S16 Planning Application for  
Proposed Temporary Transitional Housing Development with Filling and  
Excavation of Land for a Period of 3 Years at  
Lot Nos. 111 (Part), 116 to 119 in D.D.108 and Adjoining Government Land,  
Pat Heung, Yuen Long, N.T.

**S16 Planning Application for  
Proposed Temporary Transitional Housing Development for a Period of 3 Years  
with Filling and Excavation of Land at  
Lot Nos. 111 (Part), 116 to 119 in D.D.108 and Adjoining Government Land,  
Pat Heung, Yuen Long, N.T.  
(Planning Application No. A/YL-PH/887)**

**Submission of Further Information**

### **Response-to-Comments Table**

### **Revised Master Layout Plan and Ground Floor Plan**

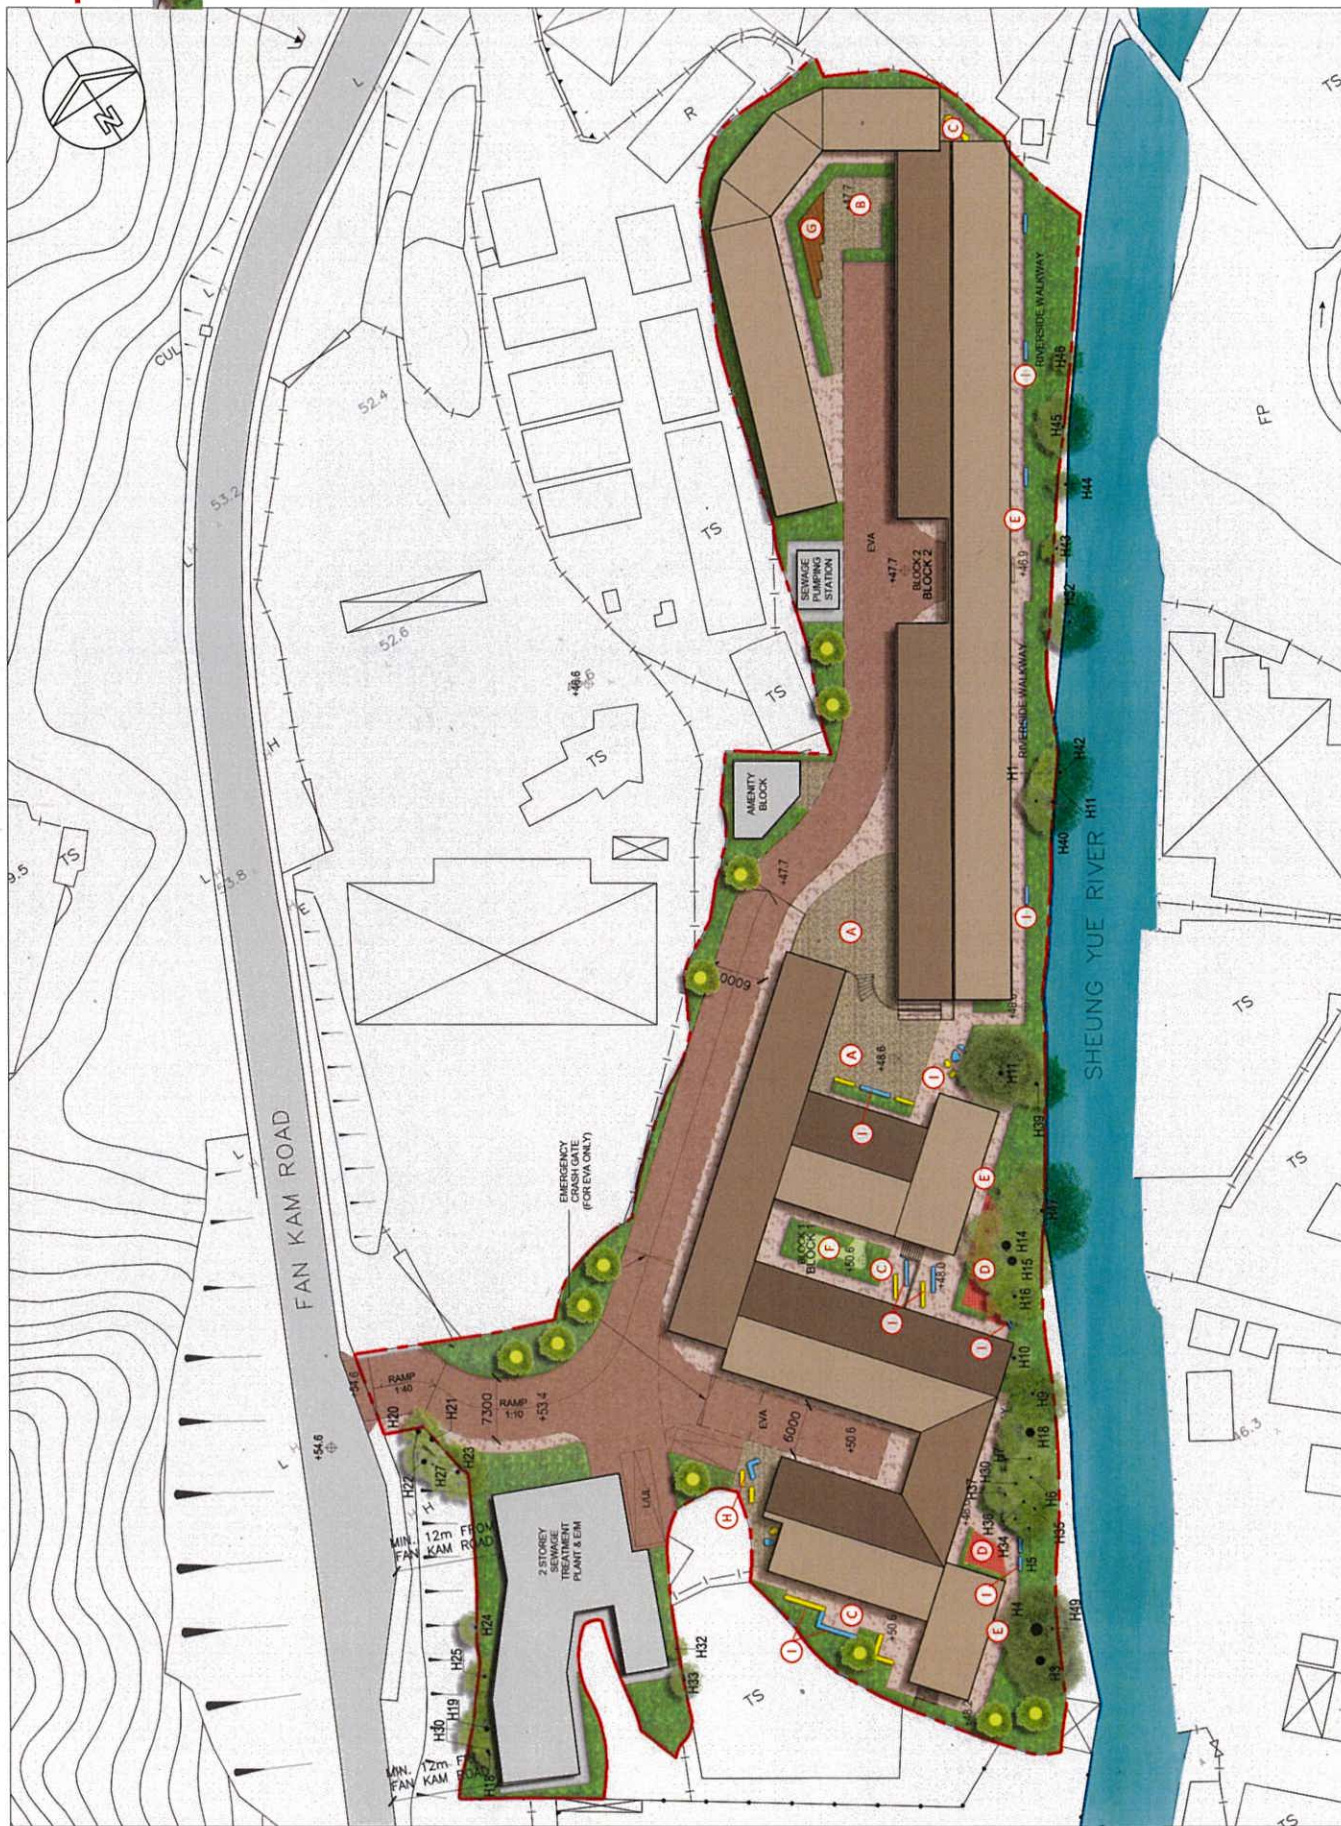
- Attachment A - Response-to-Comments Table
- Attachment B - Replacement pages of DIA
- Attachment C - Replacement page of EA
- Attachment D - Revised MLP and G/F Plan
- Attachment E - Revised Landscape Plans
